# CITY OF ALBUQUERQUE

**RE: Fire Station #9**  
**Conceptual Grading and Drainage Plan and Drainage Report**  
**Engineer's Stamp Date: 03/20/2019**  
**Hydrology File: H20D043**

Based upon the information provided in your submittal received 3/20/2019, the Conceptual Grading and Drainage Plan is approved for Site Plan only. **Prior to approval for Building Permit, and Work Order the following comments will need to be addressed.**

SPILLWAYS  $w = 5'$

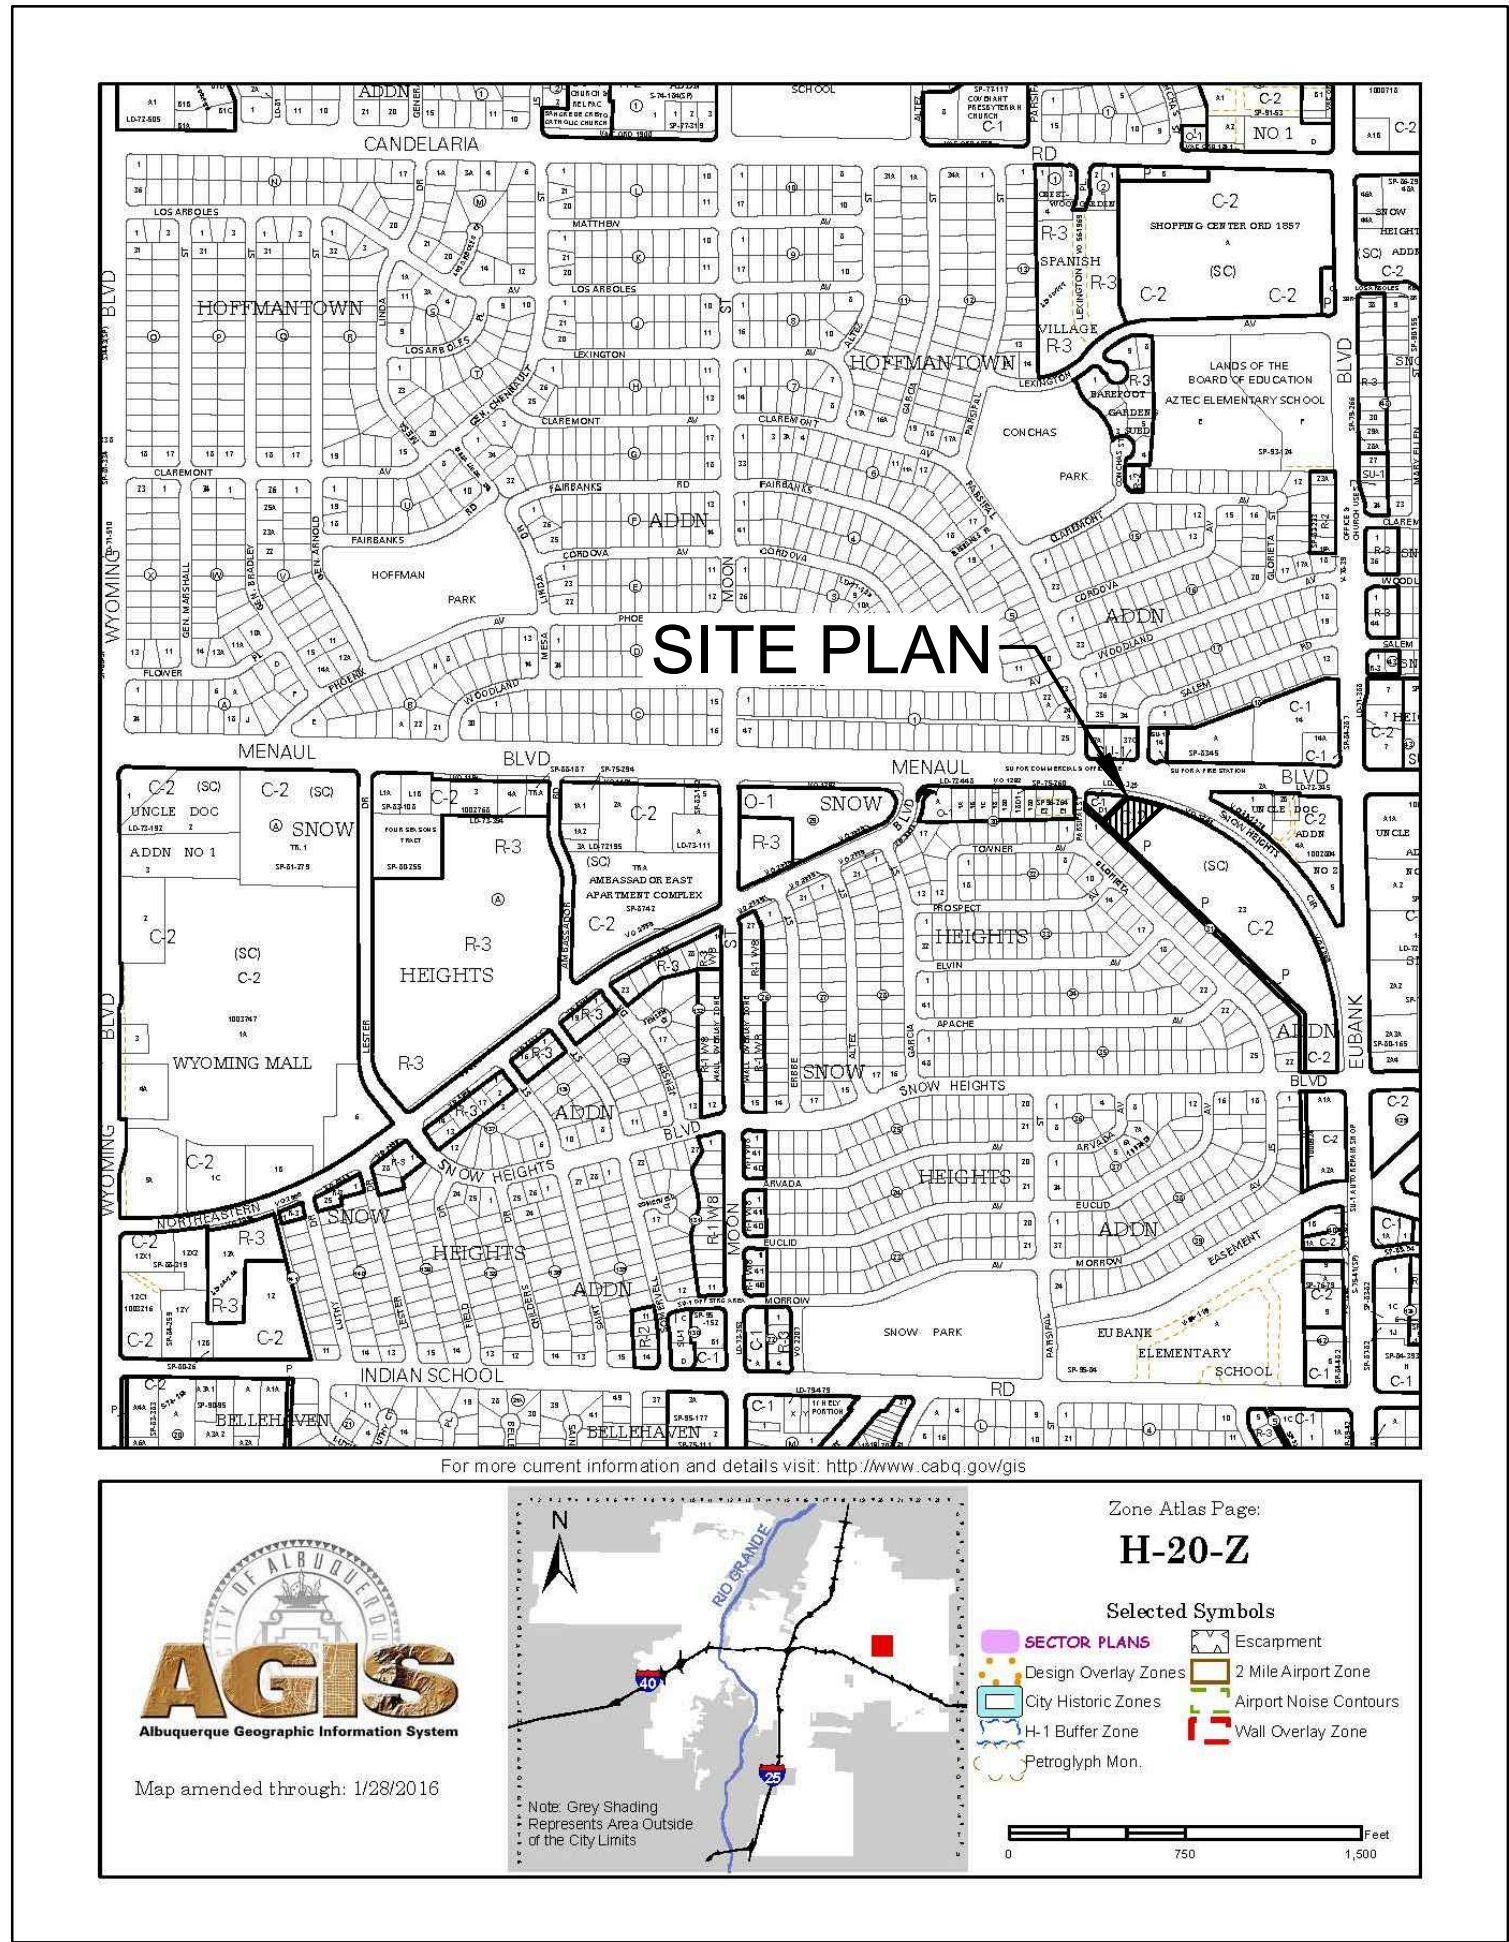
- e. Please specify the width and depth of each structure along with the peak 100 year flow rate and the weir depth calculation for each spillway and rundown into the ponds. Please correct key notes 7 and 16 to match the weir calculations.
